Additional Information with respect
to the development at Lands at
Forest Road, Swords, Co. Dublin

ADDITIONAL INFORMATION

Condition 9 of Reg Ref: LRD0057/S3E

Client: Golden Port Homes Limited

Additional Information 7:

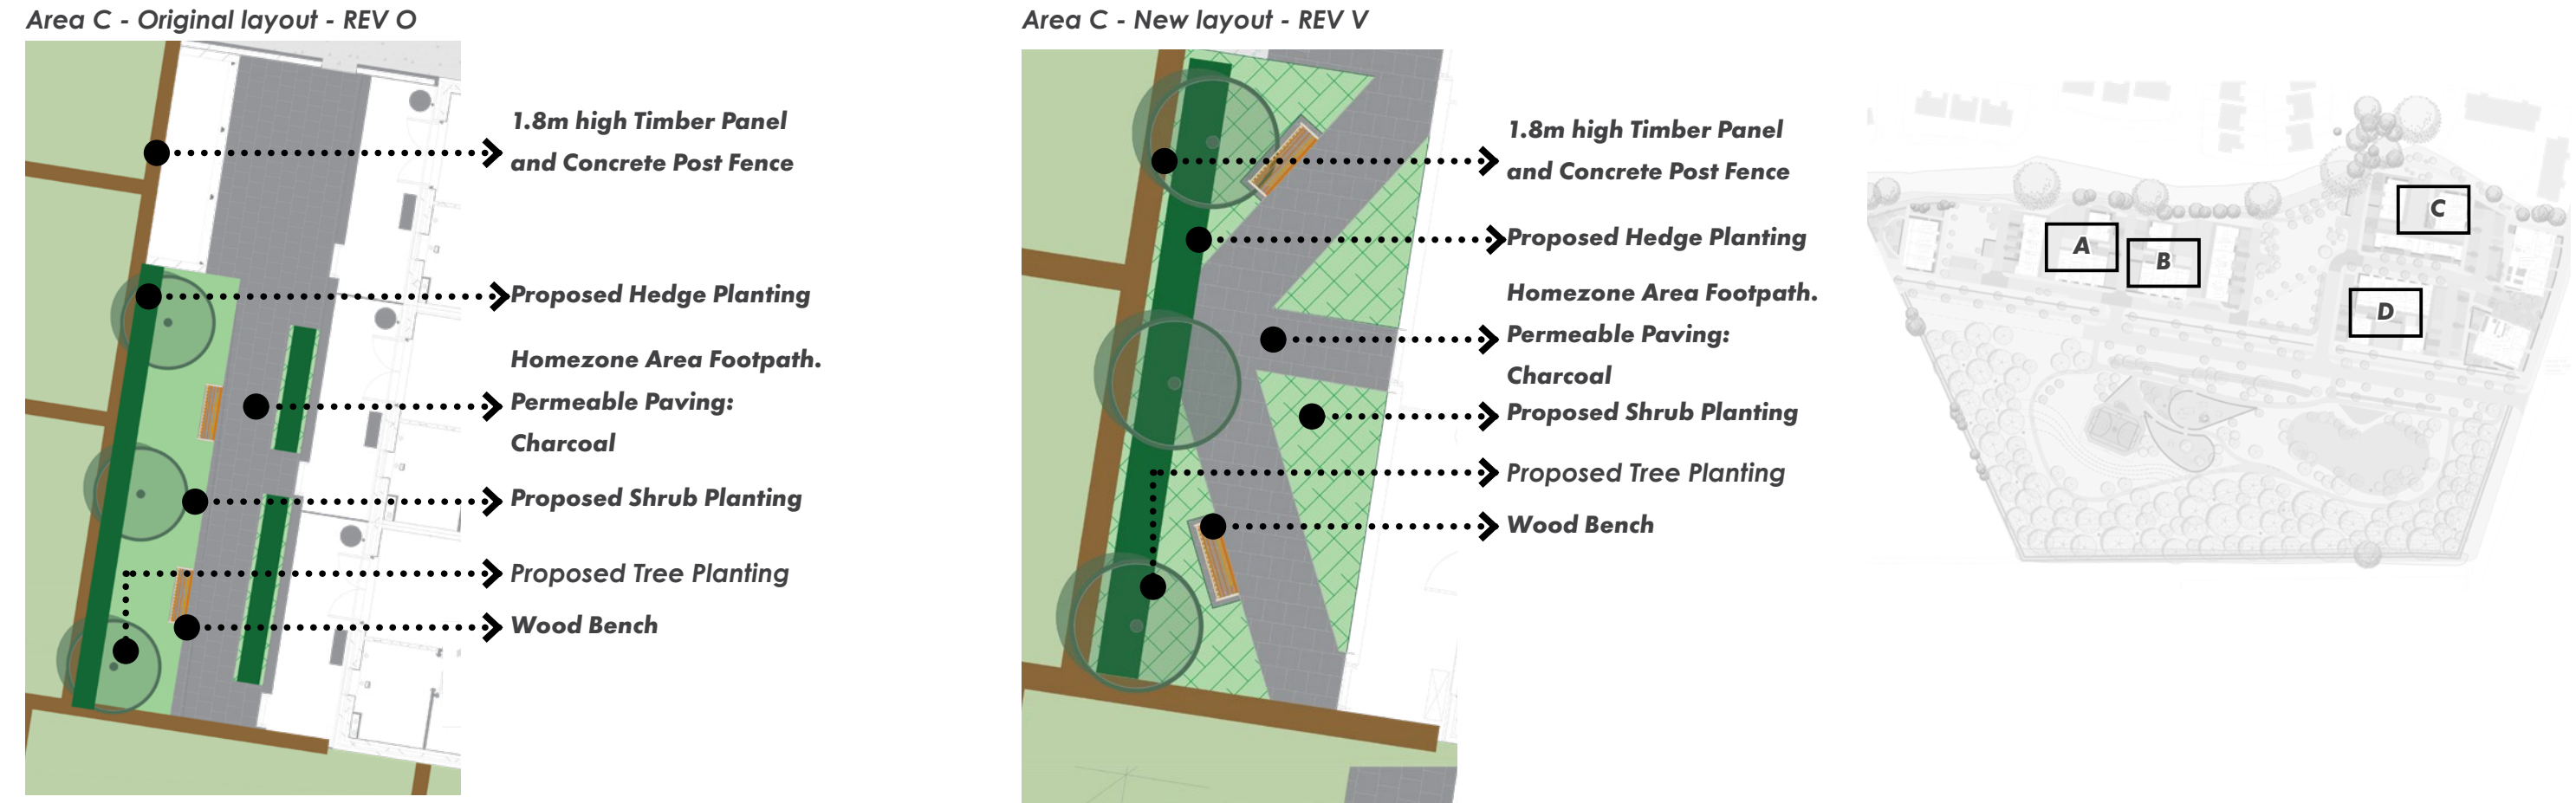
Based on the 'Daylight and Sunlight Assessment Report' submitted, the communal open spaces serving duplex units in zones B, C and D would not achieve compliance with BRE Guidelines in respect of sunlight. Furthermore, having regard to the layout and dimension of these spaces and the spaces in Zone A and serving Block B, the Planning Authority is not satisfied that a satisfactory standard of residential amenity would be afforded to future residents. The applicant is requested to submit a revised layout to address this.

The communal open spaces in Zones A, B, C, and D, as referenced in the Daylight and Sunlight Assessment Report, have been reviewed and subsequently modified through revised landscape design in order to address the concerns raised and to enhance the overall residential amenity for future occupants. Please find enclosed at this stage a diagram in this regard.

Area D - Original layout - REV O

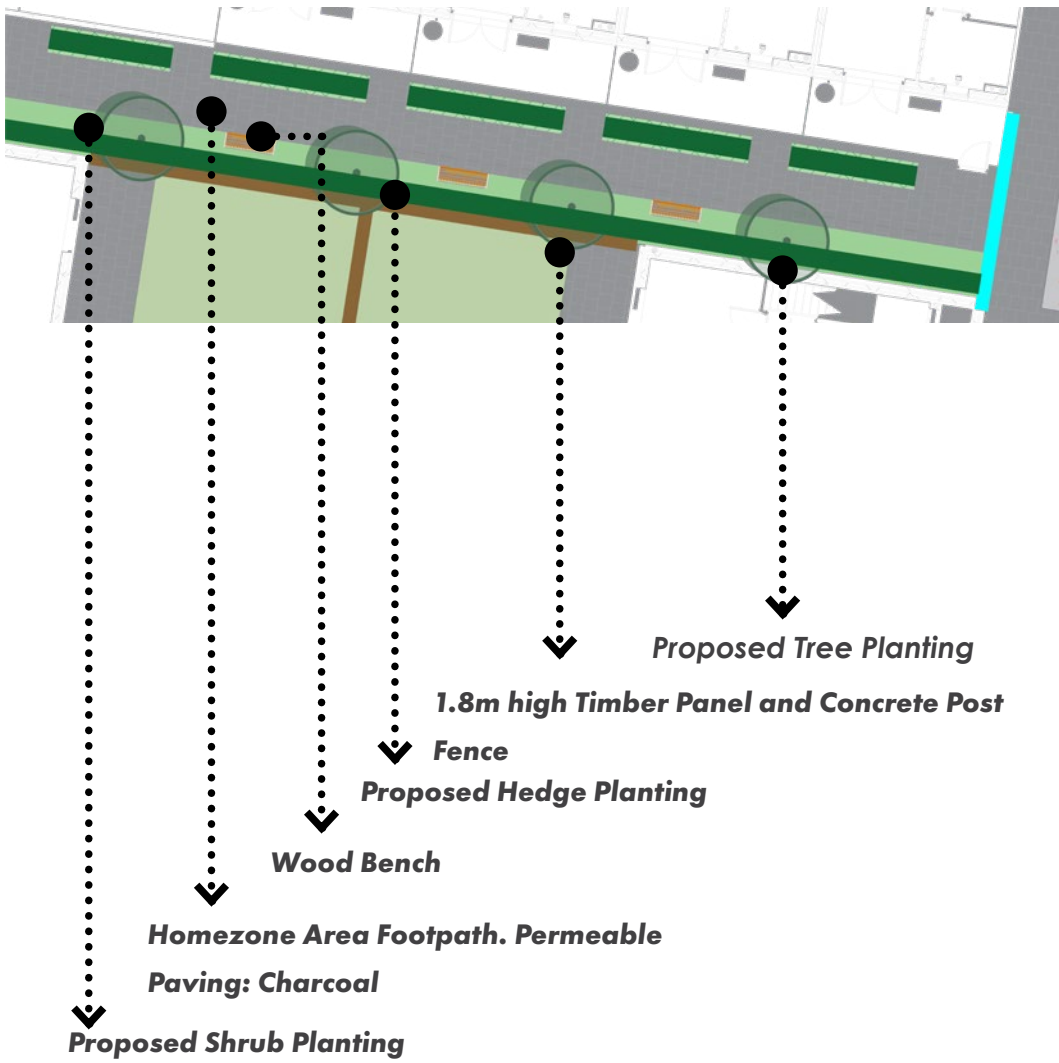
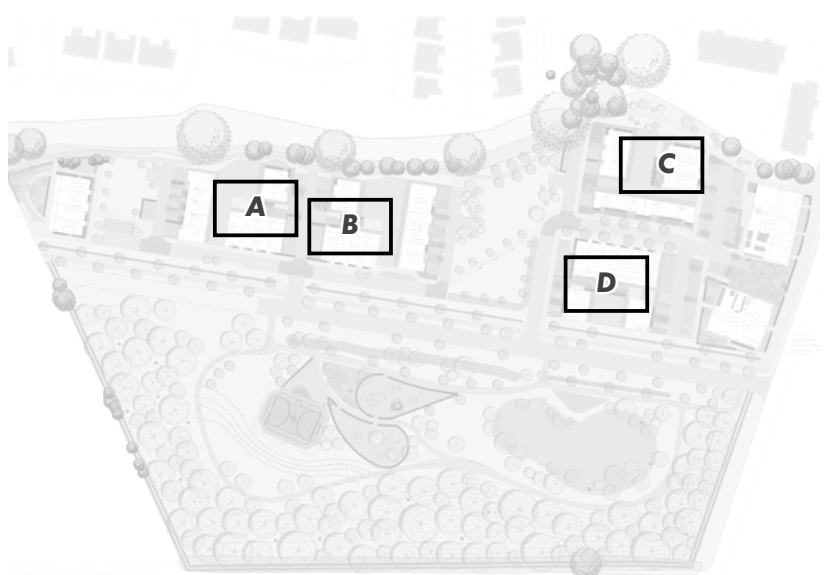
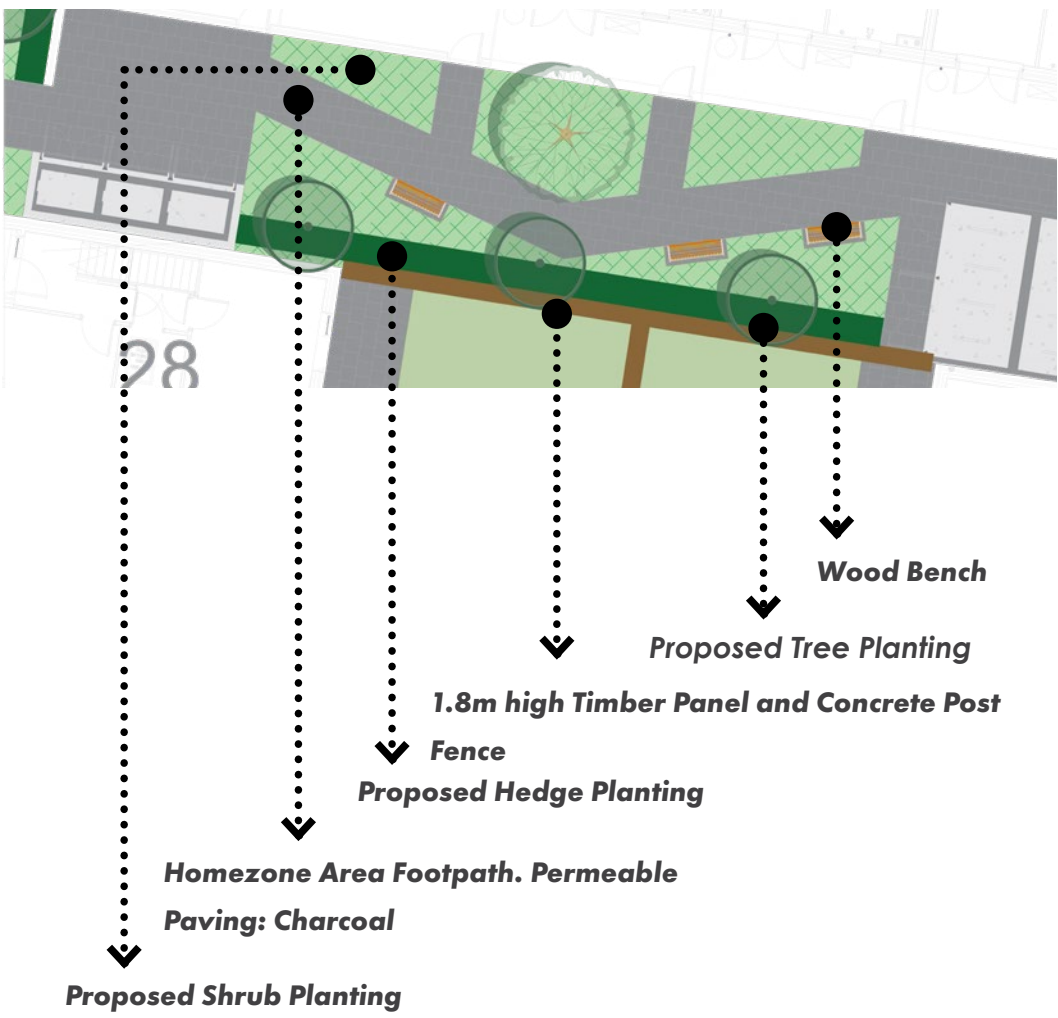
Based on the 'Daylight and Sunlight Assessment Report' submitted, the communal open spaces serving duplex units in zones B, C and D would not achieve compliance with BRE Guidelines in respect of sunlight. Furthermore, having regard to the layout and dimension of these spaces and the spaces in Zone A and serving Block B, the Planning Authority is not satisfied that a satisfactory standard of residential amenity would be afforded to future residents. The applicant is requested to submit a revised layout to address this.

The communal open spaces in Zones A, B, C, and D, as referenced in the Daylight and Sunlight Assessment Report, have been reviewed and subsequently modified through revised landscape design in order to address the concerns raised and to enhance the overall residential amenity for future occupants. Please find enclosed at this stage a diagram in this regard.

Play Area

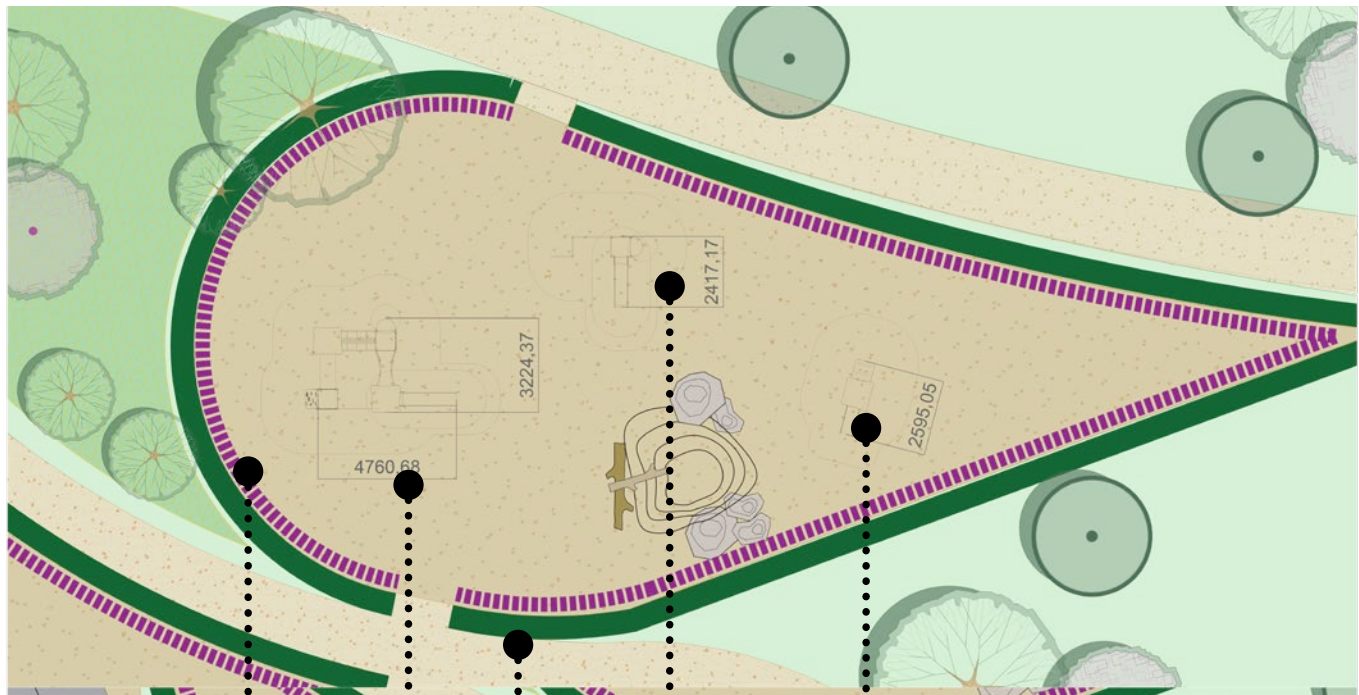
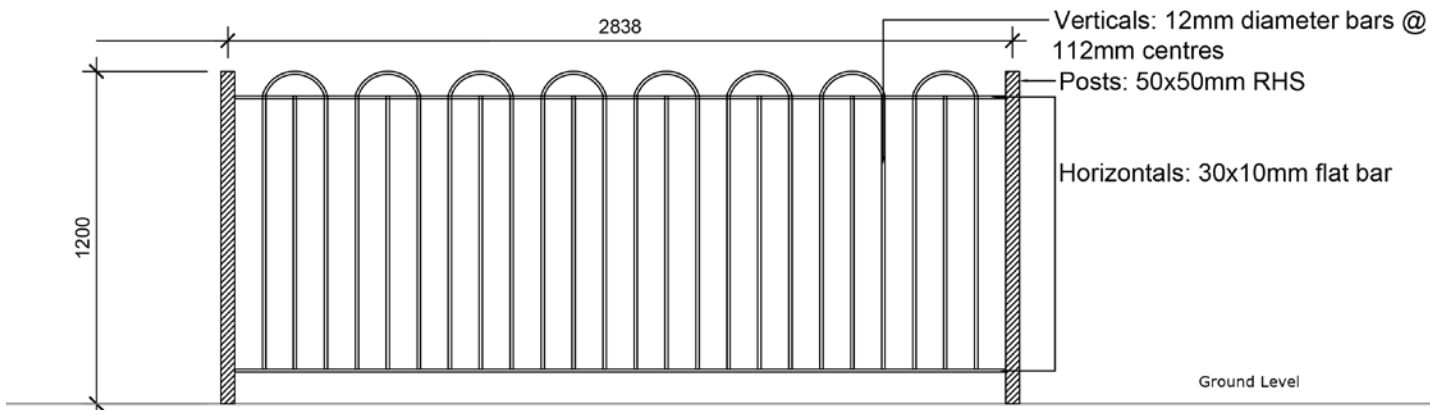
a) Details of play facilities including boundary treatment, surfacing and signage.

Please find here the detailed layout of the play area, including boundary treatment, surfacing and signage.

Play Area

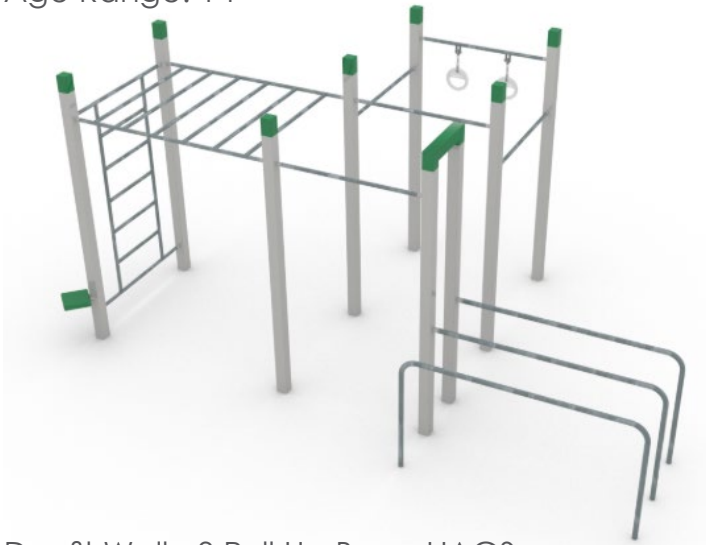
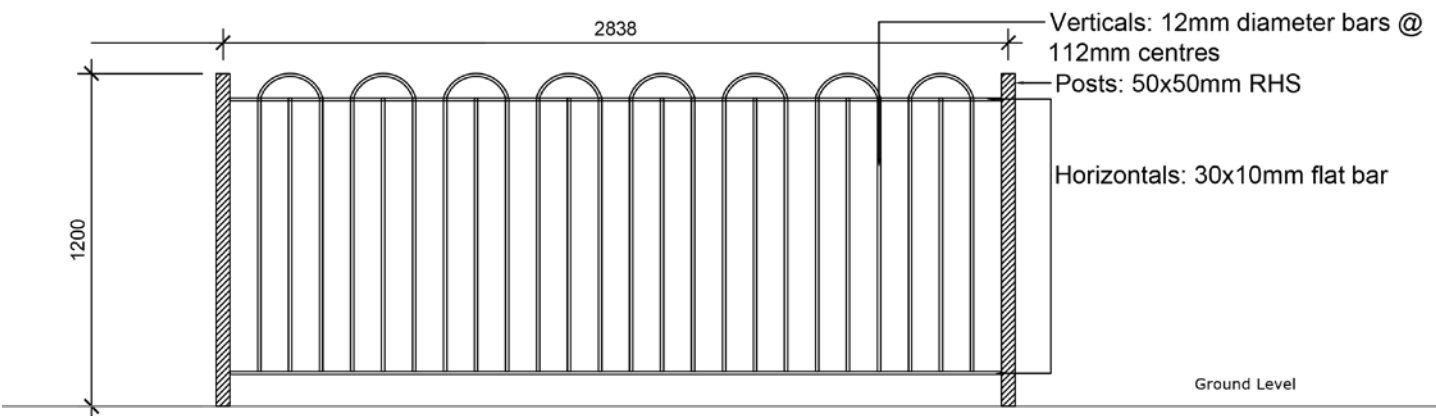
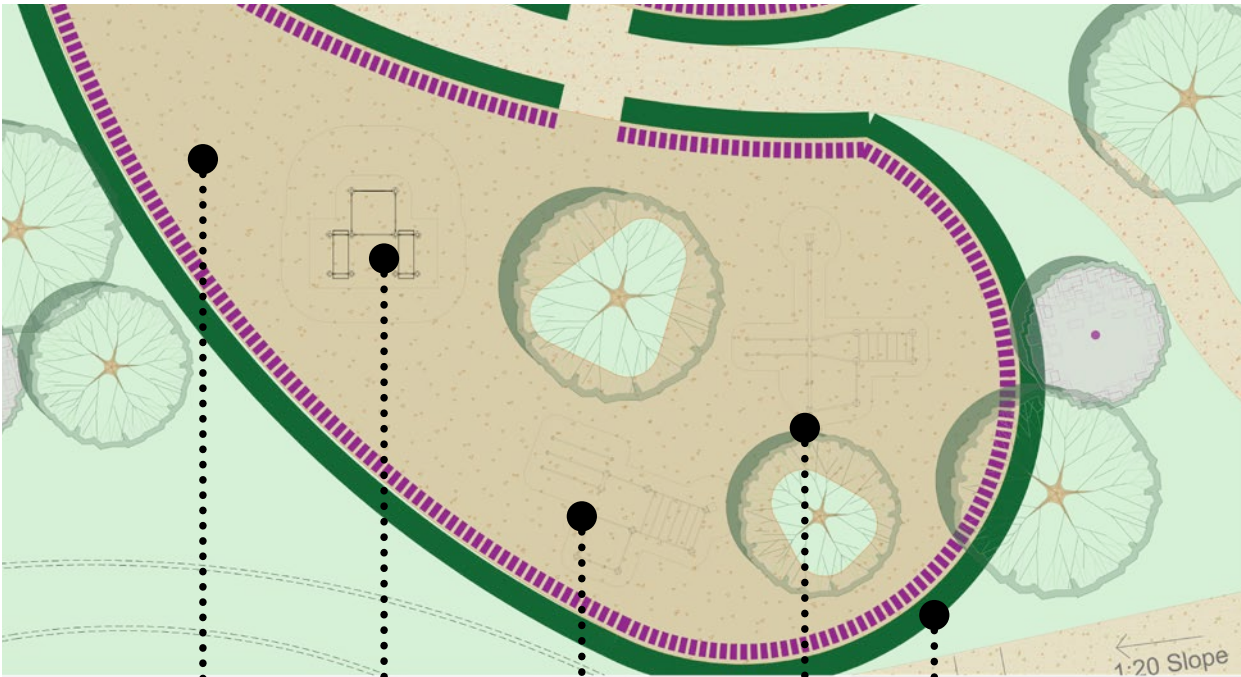
- a) Details of play facilities including boundary treatment, surfacing and signage.

Please find here the detailed layout of the play area, including boundary treatment, surfacing and signage.

1875 - REV V - DWG 11 - MUGA Plan - Forest Road - RMDA

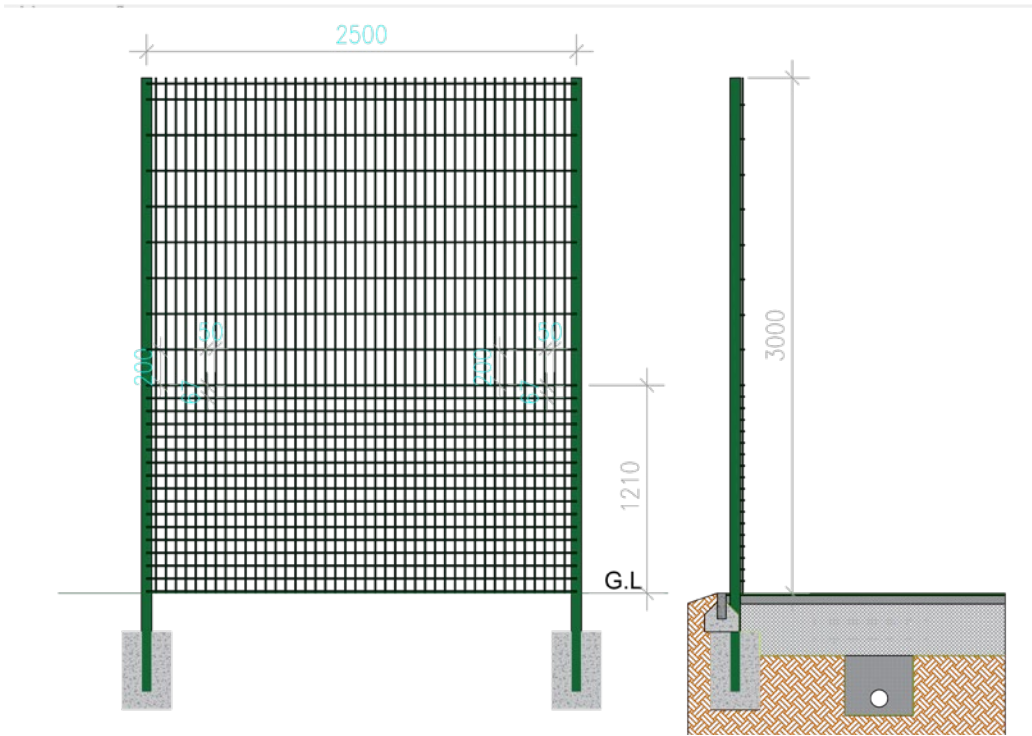
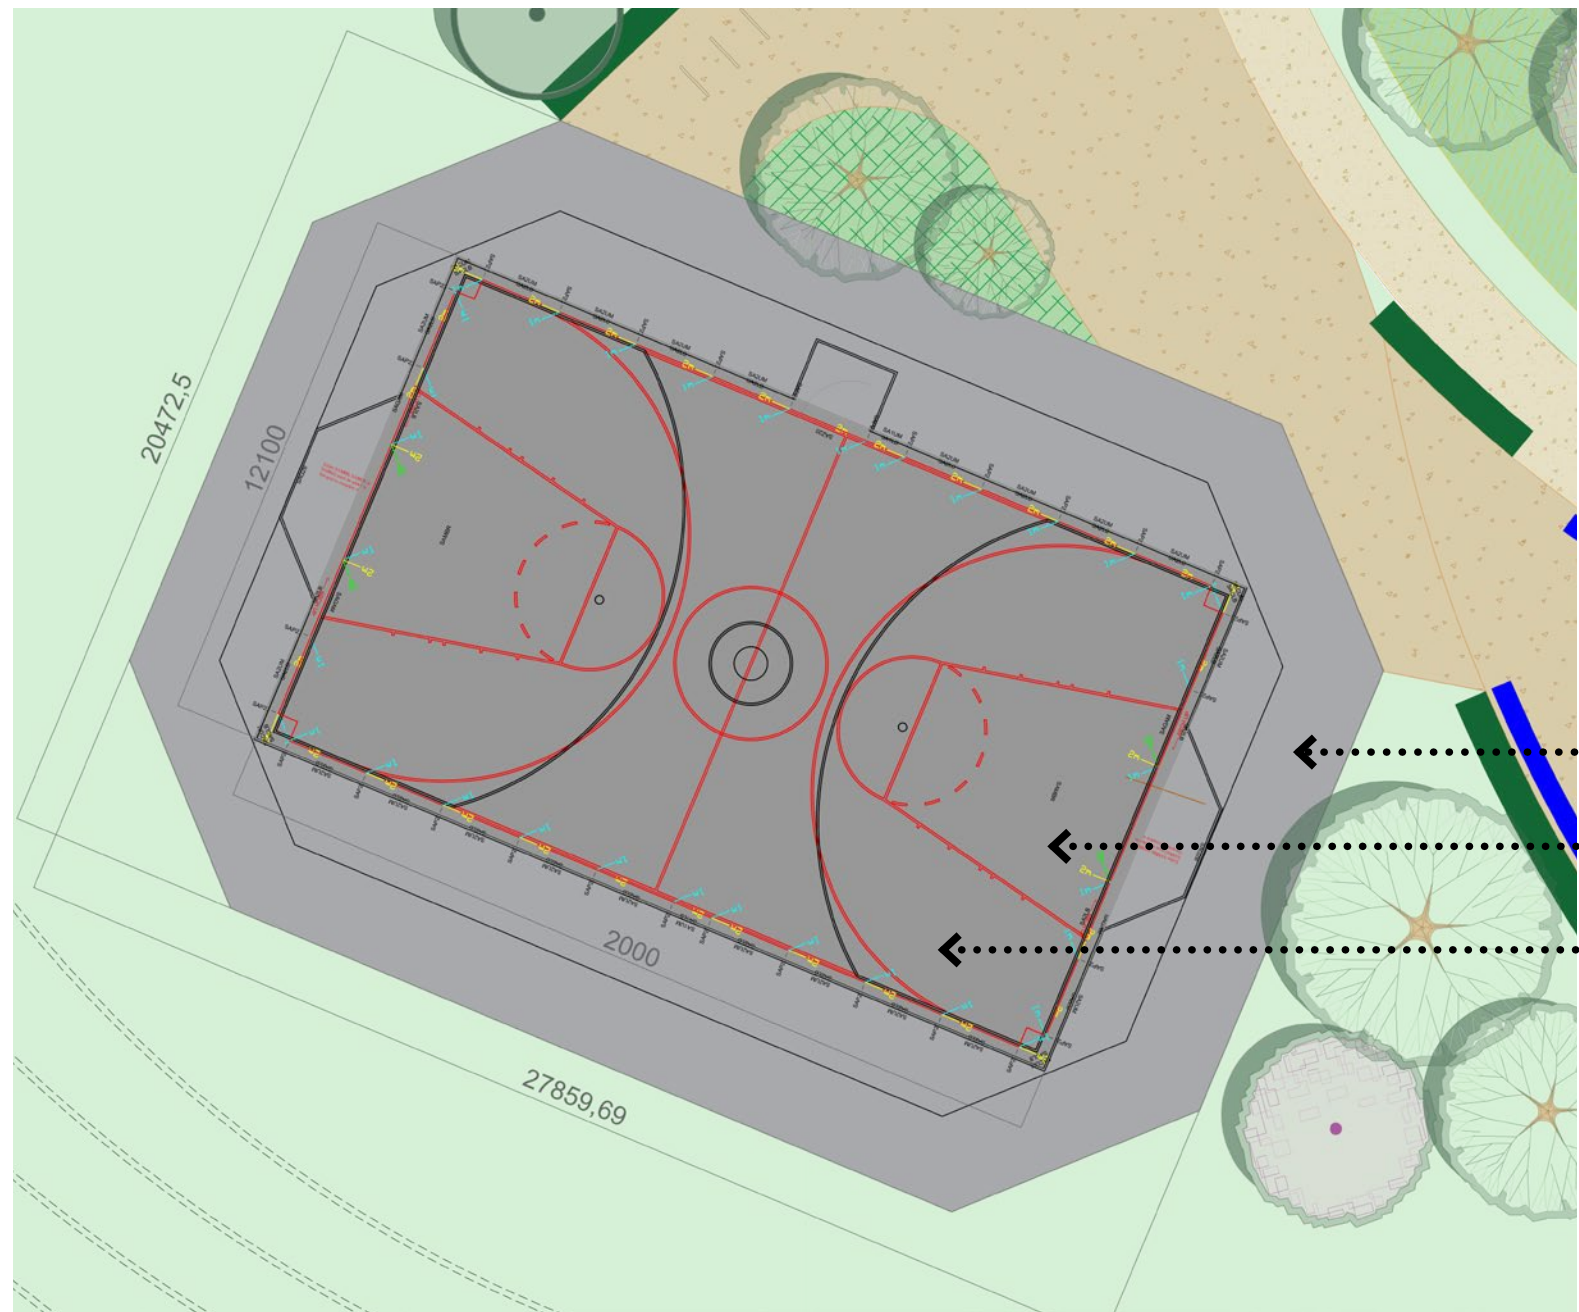
a) Details of play facilities including boundary treatment, surfacing and signage.

Please find here the detailed layout of the play area, including boundary treatment, surfacing and signage.
